Technical Service Bulletin

MAZDA CONNECT REBOOTS OR SCREEN TURNS BLACK

Bulletin No.: 09-017/21

Last Issued : 06/02/2021

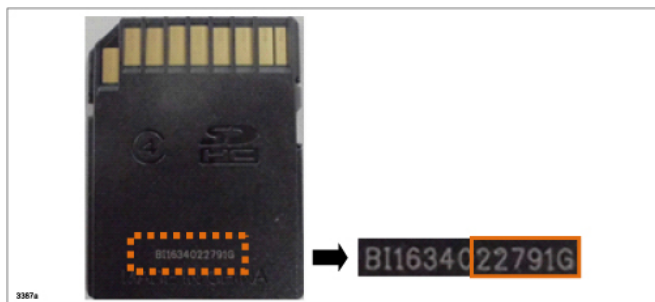
Some customers may experience the MAZDA CONNECT rebooting or the screen turning black **under any temperature**. When the concern occurs, MAZDA CONNECT reboots repeatedly, and if the SD card is removed during this reboot cycle, the rebooting cycle ends. This is caused by some SD cards for the MAZDA CONNECT navigation system being manufactured with improper hardware, resulting in a data reading error. To correct the concern, the SD card hardware has been changed.

Customers having this concern should have their vehicle repaired using the following repair procedure.
